Planning and Zoning Board
Agenda
September 14, 2021

MEETING DATE: 9/14/2021
SUBJECT: Site Plan – IIP FL 3 LLC (Harvest): A request by Rob Davis, P.E., of Wood Environment & Infrastructure Solutions, Inc., applicant and agent for IIP FL 3 LLC, property owner, for consideration of a Site Plan which proposes parking lot and site improvements and the addition of ±912 square feet of new floor area on a ±36.26 acre subject property, located at 12895 NW US Highway 441; Tax Parcel No. 05855-004-000 and 05855-004-001; FLUM: Industrial; Zoning: Industrial General (IG) (Quasi-Judicial Hearing).

Planning & Zoning Board Hearing Date: September 14, 2021
Quasi-Judicial Hearing

SUBJECT:	A request for a Site Plan proposing a new parking lot and site improvements and the addition of ±912 square feet of new floor area
APPLICANT/AGENT:	Rob Davis, P.E., Wood Environment & Infrastructure Solutions, Inc.
PROPERTY OWNER:	IIP-FL 3 LLC
LOCATION:	12895 NW US Highway 441
PARCEL ID NUMBERS:	05855-004-000; 05855-004-001
FLUM DESIGNATION:	Industrial
ZONING:	Industrial General (IG)
OVERLAY:	N/A
ACREAGE:	±36.26 acres
PROJECT PLANNER:	Justin Tabor, AICP
RECOMMENDATION:	Staff recommends that the Planning & Zoning

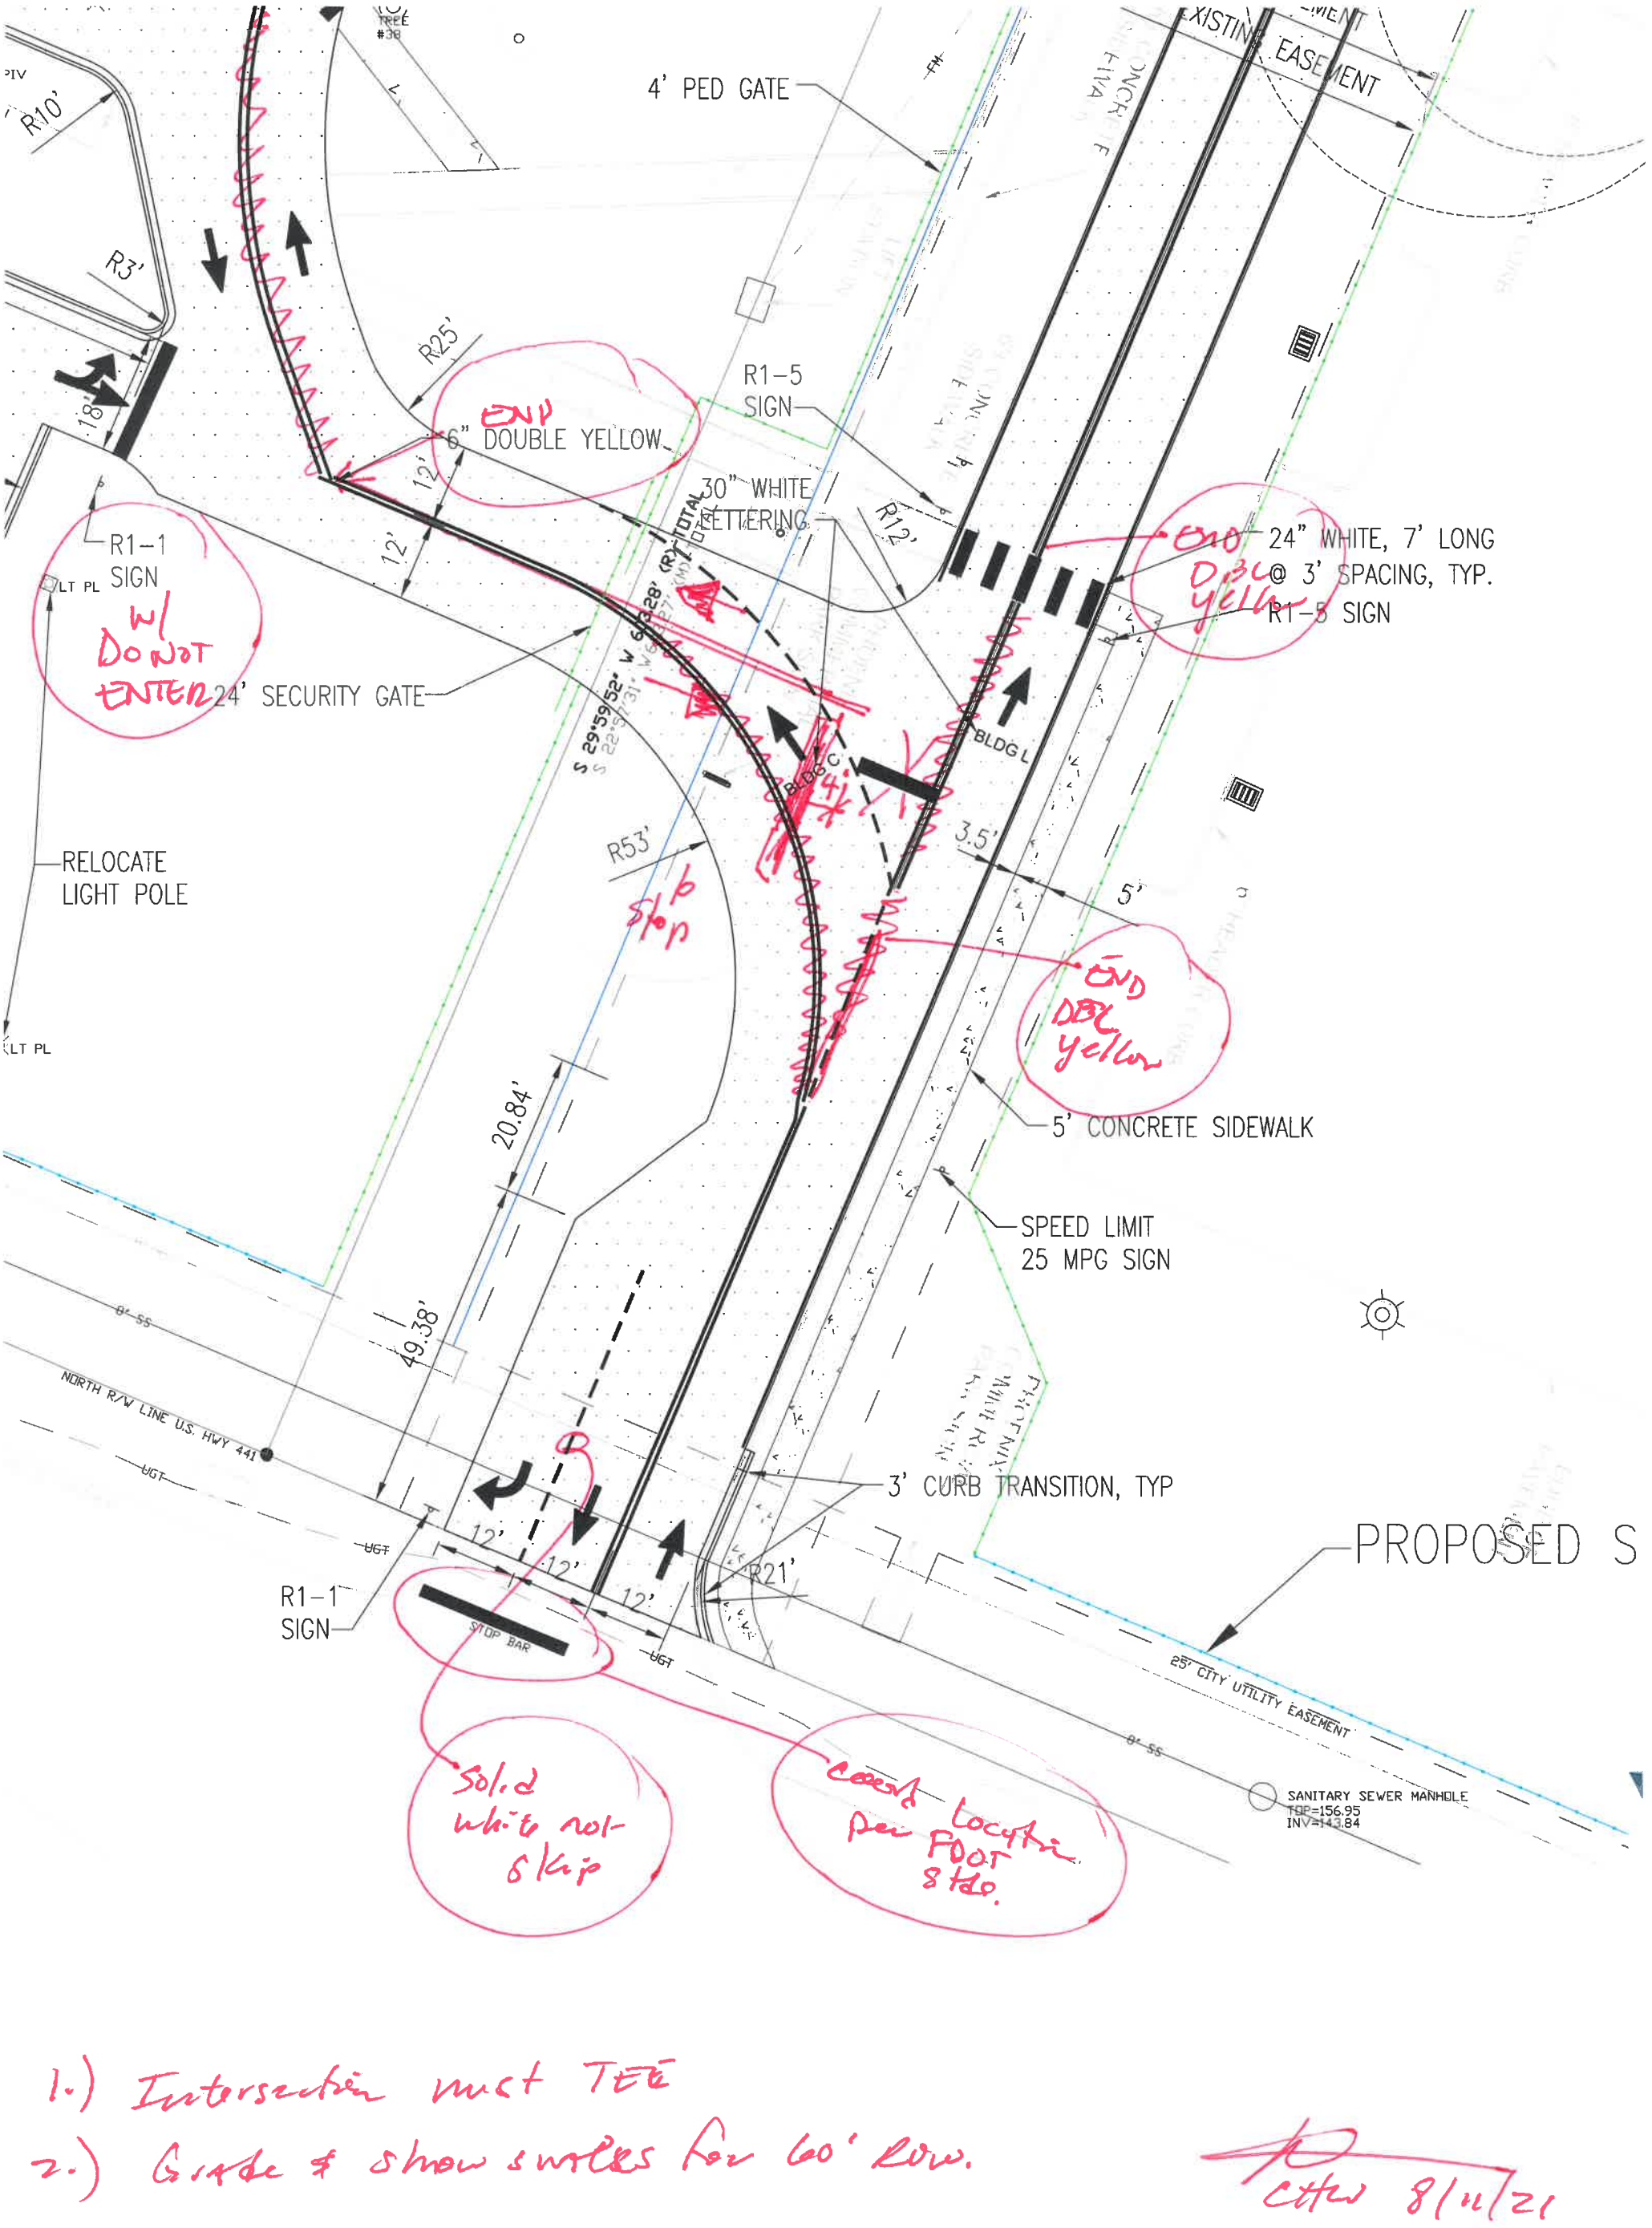
NO.	COMMENTS
1.	**Comment on July Submittal** **Sheet X-100** Minor Comment: Index to Drawings, Sheet C206: Please change spelling to "Landscape". **Approved as Noted** **Comment on Aug Submittal** **Approved**
2.	**Comment on July Submittal** **Sheet C-401** Site Utility Notes: Please replace Note1 with "1. Water and Wastewater System shall be constructed in accordance with "City of Alachua, Public Services, Design and Construction Manual, Latest Edition". Please resubmit this sheet. **Comment on Aug Submittal**

NO.	COMMENTS
	Approved
3	**Comment on July Submittal** **Sheet C-401** The 6-inch wastewater main on private property will connect to an existing CoA manhole. This is existing manhole 12 as shown on attached sheet C404. Note that this manhole connects to an existing 15-ft.long, 8-inch stubout routed to the north. Please connect the 6-inch wastewater main to this stubout. Include a cleanout. Please resubmit this sheet. **Comment on Aug Submittal** Stub-out invert is called out as 142.51, while manhole 12 invert is called out at 142.57. To promote gravity flow, stub-out invert should be higher than the manhole invert. Please review sheet C404. It appears that the manhole invert needs to change. Please **resubmit** this sheet.
4	**Comment on July Submittal** **Sheet C-401:** To Note 1, please add "WET TAP SHALL BE PERFORMED BY A SPECIALTY CONTRACTOR PRE-APPROVED BY THE CITY OF ALACHUA." **Comment on Aug Submittal** **Approved**

5	**Comment on July Submittal** **Sheet C-401:** Submittal identifies an 8-inch compound water meter. Developer to identify public water demand (i.e. fire protection requirements, etc.) and commercial water demand needs. Submit applicable document. **Comment on Aug Submittal** Submittal indicates a 6-inch compound meter. Engineer shall design the water supply connection so that it ties into the existing 12-inch main along the south side of Highway 441. **Approved as Noted**

6.	**Comment on July Submittal** **Sheet C-401:** Please review & evaluate Water Connections 1, 2 & 3: The design intent appears to be to locate the compound meter above ground as per Detail 148 & near the CoA water main. Please confirm.

NO.	COMMENTS
	Connection 3 calls out a RPZ assembly, which is shown several hundred feet from the COA water main. Yet Detail 148 shows the RPZ near the above ground meter, which is connection 2. Also, above ground piping is ductile iron (DI). Suggest showing the transition from DI pipe to buried PVC pipe. Modify as necessary & resubmit this sheet. **Comment on Aug Submittal** Especially because CoA will be responsible for meter maintenance, CoA has a strong preference that the meter be located above grade. Also, note that the existing Harvest water meter installed about 2 years ago is above grade. Thus, please include Detail 148 in the Contract Plans. Note that this detail shows both the water meter and next to it a RPZ assembly, which must be located there to protect the municipal water supply. Because detail legend 2 now also includes the RPZ assembly, please call it out. The detail on C-503 called "Potable Water 4-inch and larger water meter & backflow preventer assembly" should be deleted because it currently no longer shows an above ground water meter Detail Legend 3 calls out a NY Watts RPZ assembly several hundred feet downstream the water meter. The CoA takes no objection to this additional RPZ assembly as it will be on private property, and the CoA water meter has its own dedicated RPZ as per Detail 148. The detail required to install this RPZ assembly (detail legend 3) is left to the discretion of the Engineer. Please **submit** the applicable sheet.

7.	**Comment on July Submittal** **Sheets C-503 & C-504.** It appears that PDF versions of CoA details comprise these sheets. To improve clarity, it is suggested to replace with CAD versions of these details. Please re-submit these sheets. **Comment on Aug Submittal** **Approved**

8.	**Comment on July Submittal** **Sheet C-503:** Add cross-reference details 307 & 315. Also to Detail 149, please add the following text for Keyed Note 1: "RESTRAIN WITH EBAA IRON RESTRAINT HARNESS OR EQUAL. HARNESSES SHALL INCLUDE SPLIT SERATED RESTRAINT RINGS". Please resubmit this sheet. **Comment on Aug Submittal**

NO.	COMMENTS
	Approved
9.	**Comment on July Submittal** **Sheet C-504:** FYI: Detail 215 cross-references Details 209 & 216, but these details are not required for this project. **Approved**

11.	**(New) Comment on Aug Submittal** **Sheet-401** Please call out "END OF COA MAINTENANCE" at two locations: • At the cleanout of the 8-inch stub-out, which is now connected to a gravity main. • At the water meter (Detail Legend 2). Please **resubmit** this sheet.
END OF COMMENTS

X-100

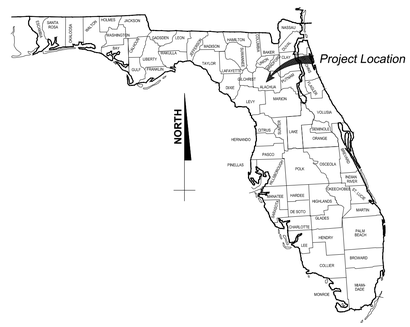
1. Change spelling to Landscape, sheet X100.
RESPONSE: Revised and thank you.

Figure 1

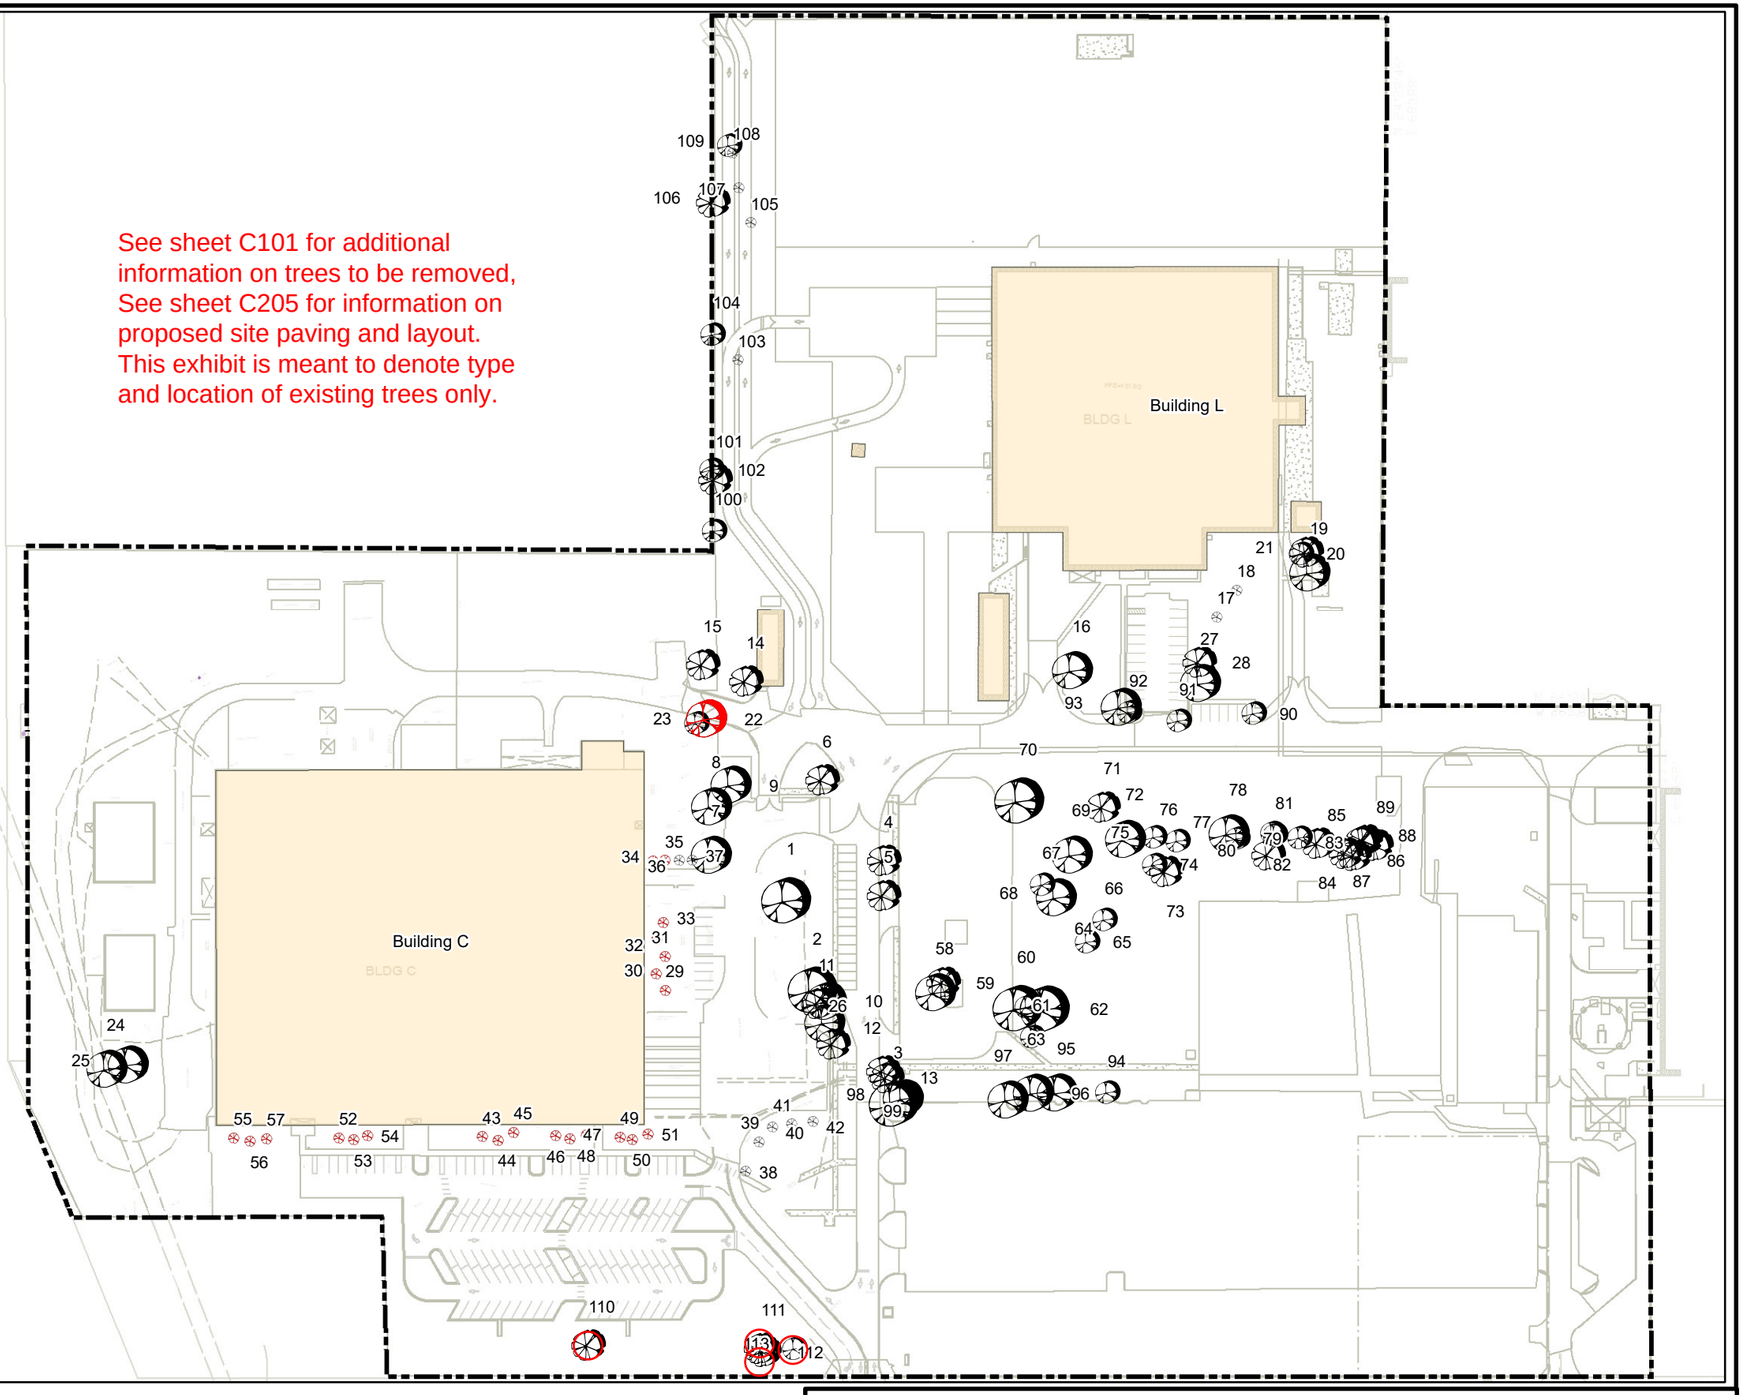
7. *Miscellaneous*
   a. Existing Tree Survey Map (Figure 1) shows proposed site improvements that are no longer part of the scope of the project. Revise accordingly.

TREE BARRICADE

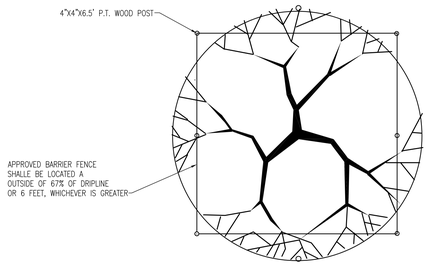
c. Tree barricade and barrier detail shown on Sheet C-501 do not specify minimum area required tobe within protected area. Reference Section 6.2.1(D)(2) and revise details accordingly.

c. Tree barricade and barrier detail shown on Sheet C-501 do not specify minimum area required to be within protected area. Reference Section 6.2.1(D)(2) and revise details accordingly.

RESPONSE: Tree Barricade detail on sheet C501 is revised to indicate distance from tree dripline. Tree barricades are added for the trees alongside the new roadway and two (2) trees off the southwest corner of Building C. Please see revied sheet C101 for tree barricade locations.

C-503

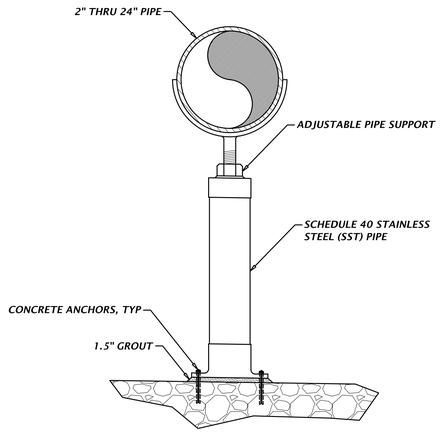
8.	**Comment on July Submittal** **Sheet C-503:** Add cross-reference details 307 & 315. Also to Detail 149, please add the following text for Keyed Note 1: "RESTRAIN WITH EBAA IRON RESTRAINT HARNESS OR EQUAL. HARNESSES SHALL INCLUDE SPLIT SERATED RESTRAINT RINGS". Please **resubmit** this sheet.

7. Replace pdf versions of details on sheets C503 and C504 with CAD versions.
RESPONSE: Thank you for sending the CAD files. Sheets C503 and C504 are revised and include removal of water meter components on City detail 148.

RESPONSE:Details 307 and 315 are added to sheet C504. Provided language is shown on detail 159 on sheet C503.
